Long Range Transportation Plan - 2018 Update

## APPENDIX A: Public Comments

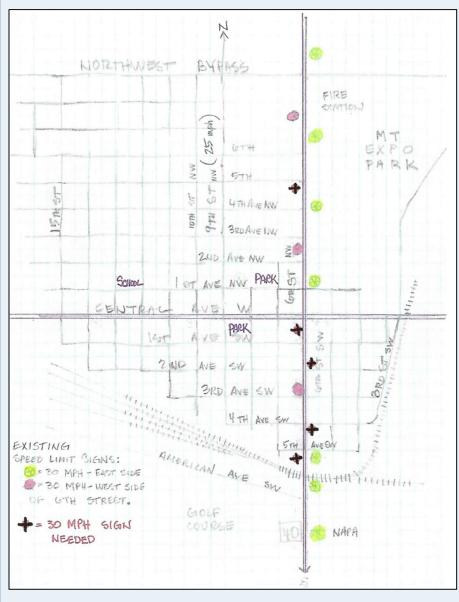
I attended the open house meeting on May 10. Thank you for the markings that you made on the map to indicate the areas with issues and for listening to my concerns:

- increasing speeding on 6th Street SW between Central Ave W and American Wav.
- lack of speed limit signing between Central and 4th Ave SW.
- lack of safe crossings for pedestrians and other non-motorized users (failure of drivers to yield),
- routing airport traffic from Central Ave W to south on 6th Street SW to an already dysfunctional intersection at 10th Ave SW.

I documented locations of current 30 mph Speed Limit signs and identified that in the area of concern there is only one sign at 3<sup>rd</sup> Ave SW on the west side of the street, none on the east side of the street.

- 3. Appendix F: Facility Recommendations 5.4 Spot Improvements, p. 52: Please add 6th Street SW spot crossing improvements at 2nd Ave SW and at 3<sup>rd</sup> Ave SW which would allow pedestrians and other non-motorized users (people on bicycles, in wheelchairs and strollers) to cross the street in a predictable and designated place. This would include highly visible marked crosswalks that glow in headlights with pedestrian crossing signs.
